World Forum for Harmonization of Vehicle Regulations

Working Party on Passive Safety

Report of the Working Party on Passive Safety on its sixtieth session

"6.3.5.1. Support-leg and support-leg foot geometrical requirements

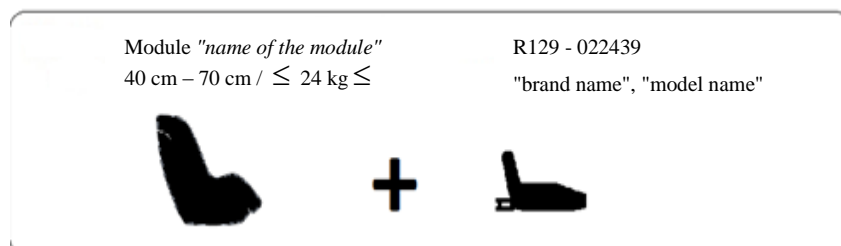
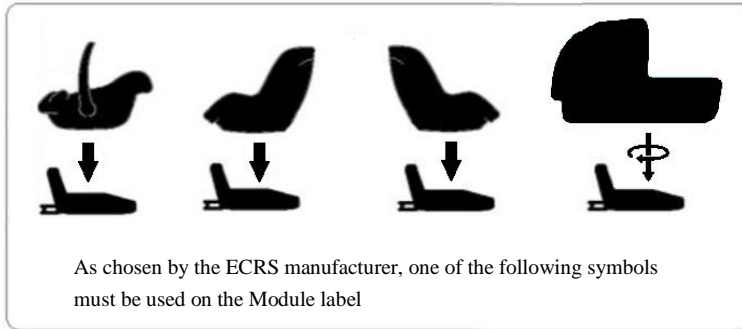
The support leg, including its attachment to the Enhanced child restraint systems and the support-leg foot shall lie completely within the support leg dimension assessment volume (see also figures 1 and 2 of annex 19 of this Regulation), which is defined as follows:

- (a) In width by two planes parallel to the X'-Z' plane separated by 200 mm, and centered around the origin; and
- (b) In length by two planes parallel to the Z'-Y' plane and positioned at distances of 585 mm and 695 mm forward of the origin along the X' axis; and
- (c) In height by a plane parallel to the X'-Y' plane, positioned at a distance of 70 mm above the origin and measured perpendicular to the X'-Y' plane. Rigid, non-adjustable parts of the support leg shall not extend beyond a plane parallel to the X'-Y' plane, positioned at a distance of 285 mm below the origin and perpendicular to the X'-Y' plane.

The support-leg may protrude the support-leg dimension assessment volume, providing it remains within the volume of the relevant CRF."

"6.3.5.1. Support-leg and support-leg foot geometrical requirements

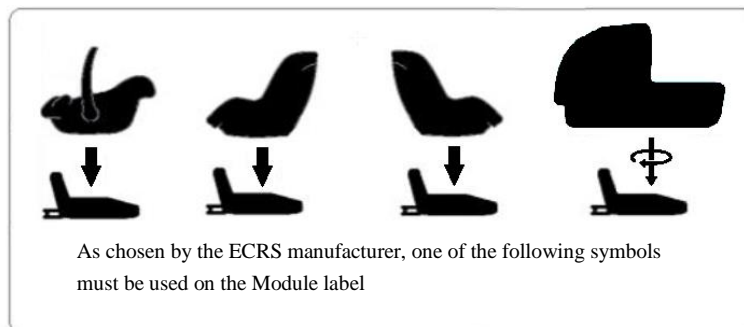
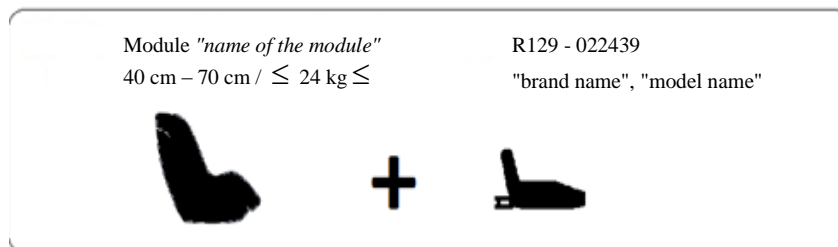
The support leg, including its attachment to the Enhanced child restraint systems and the support-leg foot shall lie completely within the support leg dimension assessment volume (see also figures 1 and 2 of annex 19 of this Regulation), which is defined as follows:

- (a) In width by two planes parallel to the X'-Z' plane separated by 200 mm, and centered around the origin; and
- (b) In length by two planes parallel to the Z'-Y' plane and positioned at distances of 585 mm and 695 mm forward of the origin along the X' axis; and
- (c) In height by a plane parallel to the X'-Y' plane, positioned at a distance of 70 mm above the origin and measured perpendicular to the X'-Y' plane. Rigid, non-adjustable parts of the support leg shall not extend beyond a plane parallel to the X'-Y' plane, positioned at a distance of 285 mm below the origin and perpendicular to the X'-Y' plane.

The support-leg may protrude the support-leg dimension assessment volume, providing it remains within the volume of the relevant CRF."
